SUBJECT: Request for minor turbine location changes for the Thunder Spirit Wind Energy Project, Adams County, ND (Case No. PU-11-601)

Attachment 1
Figure – Permitted Turbine Locations Compared to
Base Case Layout

Summary of Footprint Impacts Associated with Redesign of the Thunder Spirit 78 turbine 150MW PSC-permitted Layout
Compared to a 43 turbine 107.5MW Layout

ADMINISTRATIVE UPDATE

Figure 2 Project Area (Aerial) Base Case Layout

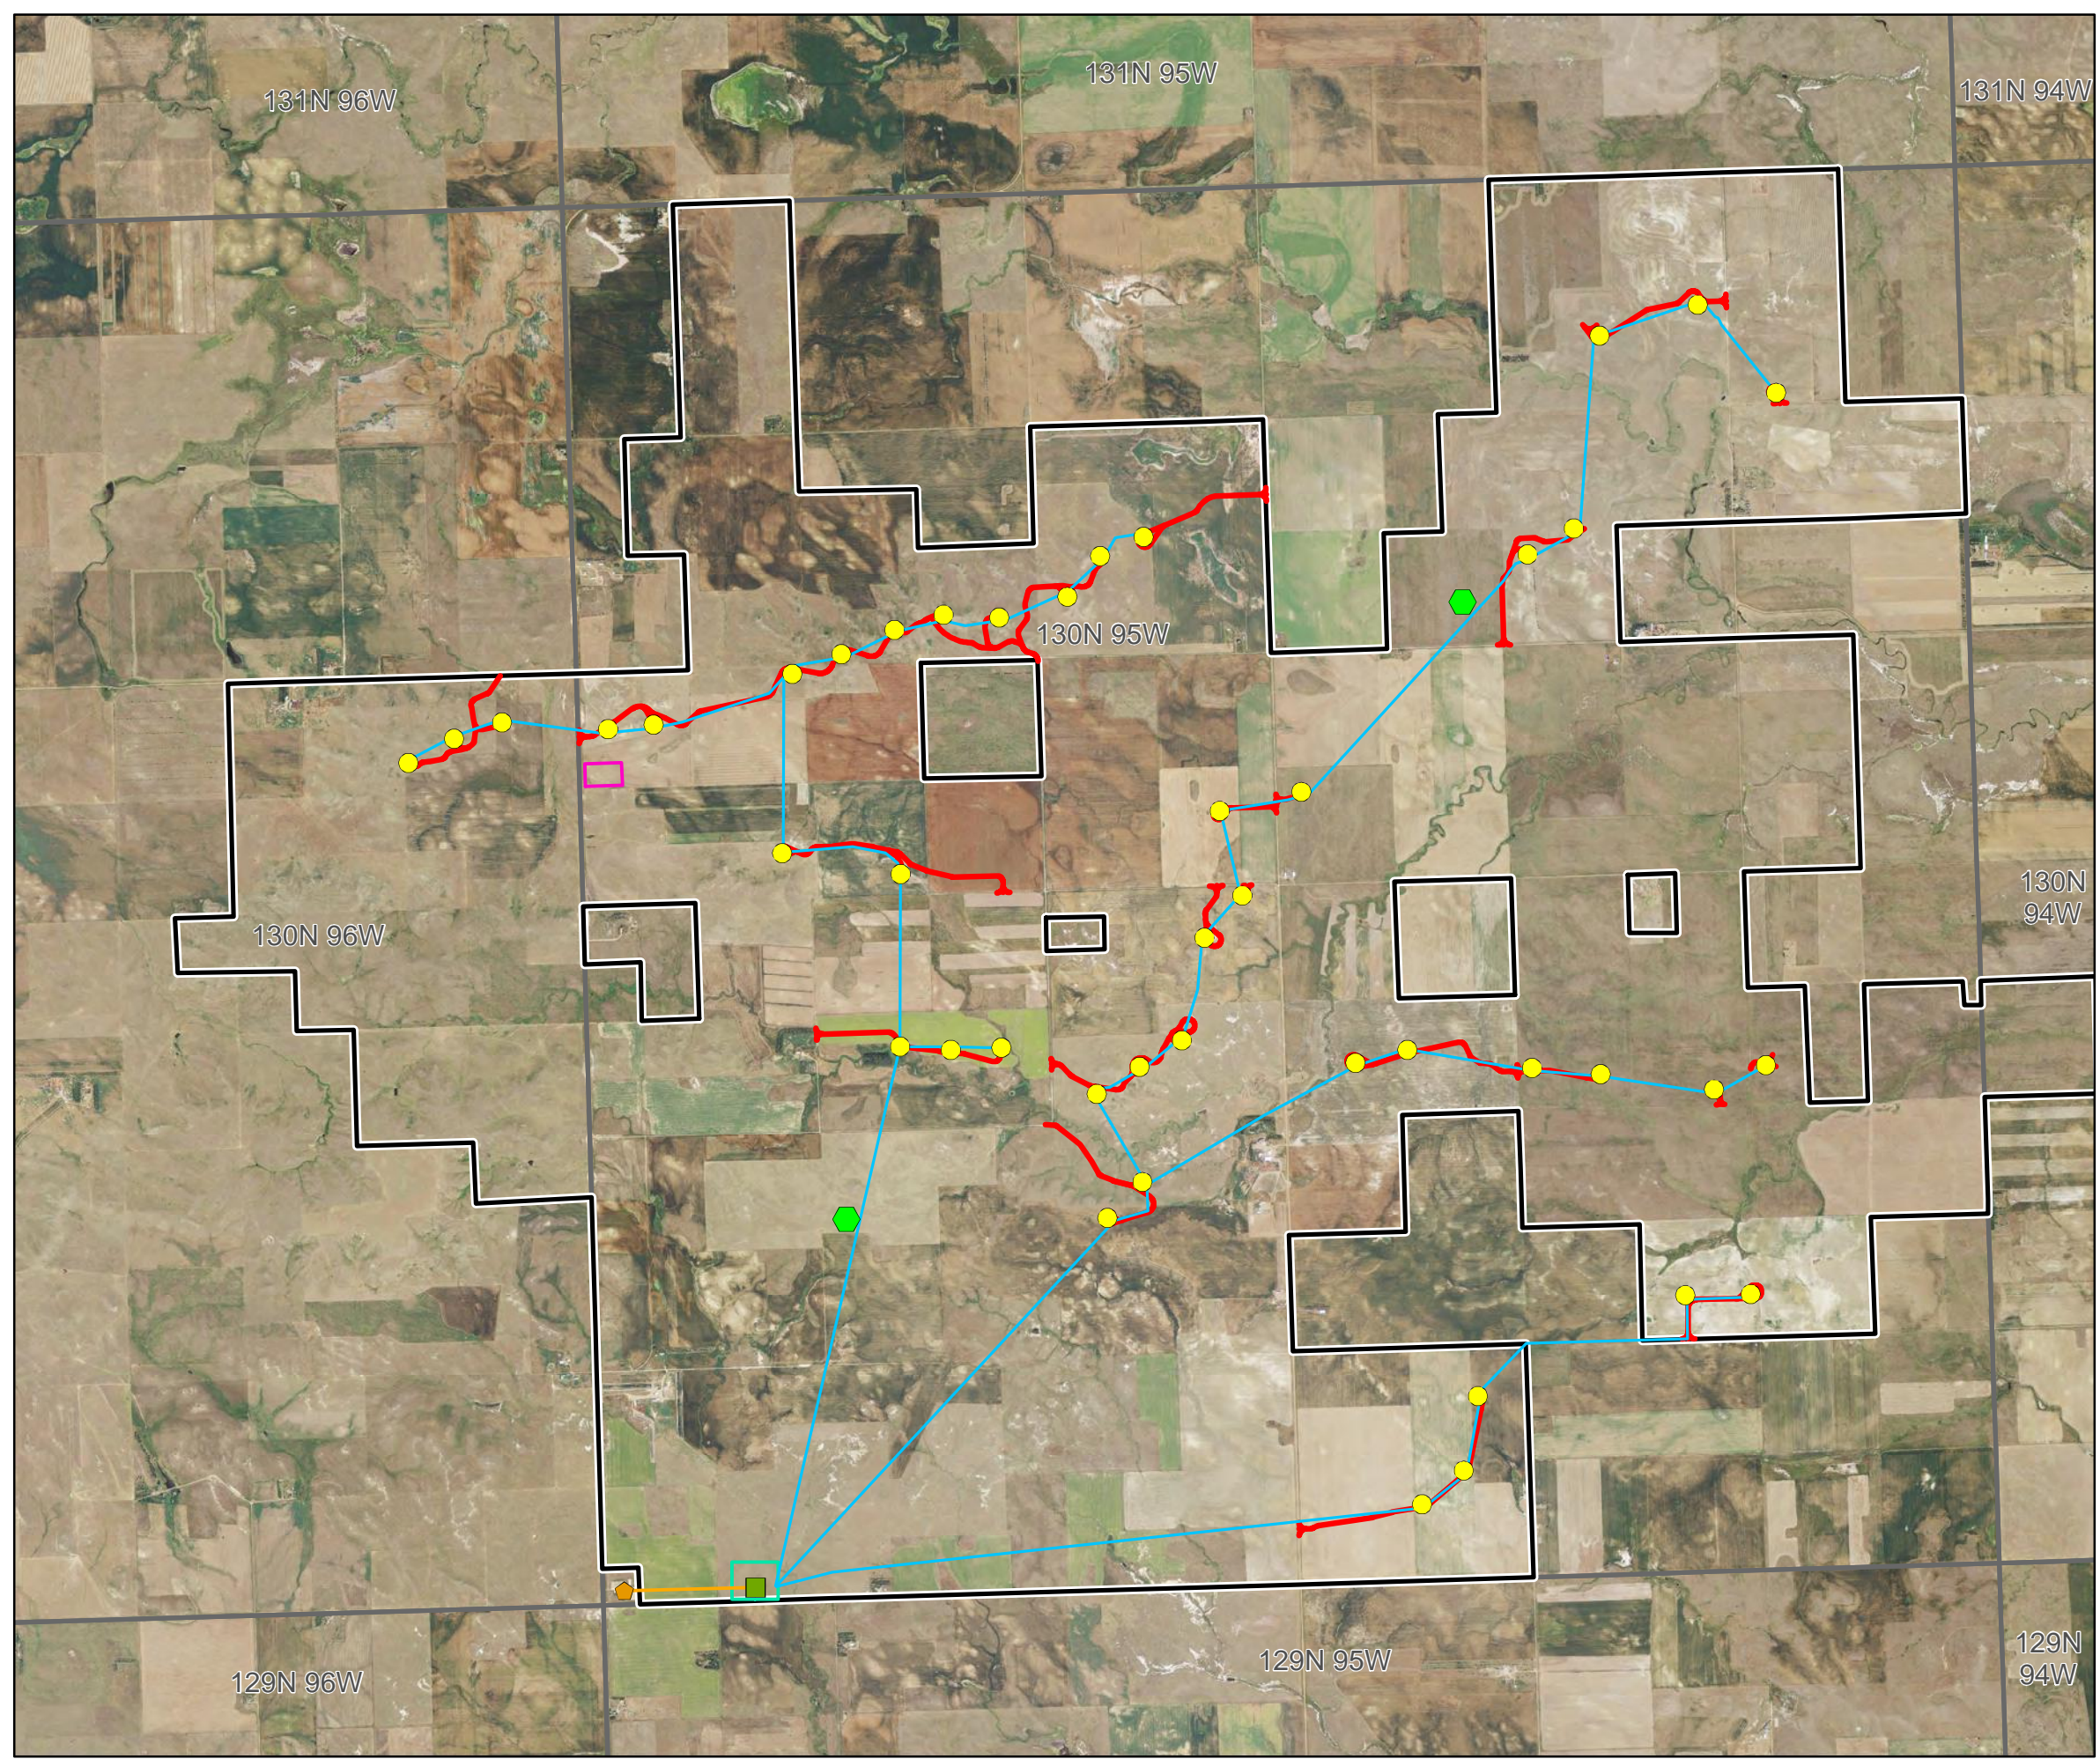
Of the 43 turbine locations in the Base Case, all are within the areas surveyed for the June 2013 Application. Locations have been adjusted to optimize production and avoid resource impacts, resulting in shifts of under 1 foot to approximately 5.29 feet. Where such shifts resulted in roads or collection lines being moved out of a previous survey corridor, additional surveys were performed. This additional field survey work was limited to wetlands and cultural resources, as previously-performed surveys covered the entire Project Area. In addition, some desktop analyses were conducted. These include a revised sound analysis, revised shadow flicker analysis, and impact calculations. **Table 1** shows the adjustments made to these Project components for the Base Case; Figure 2 shows the proposed locations for the turbines, access roads and underground collection lines for the Base Case.

The current Base Case layout (dated May 27, 2014) will utilize 43 turbine locations. Since the total number of turbines was not increased, rather it was decreased, there are no additional impacts to those originally presented for native prairie, prime farmland, agricultural production and plant life and these total impacts will be less than those presented previously. Should a second phase of the project be built (~ 42.5 MW), the total impacts are expected to approximate those originally presented for an overall 150 MW project.
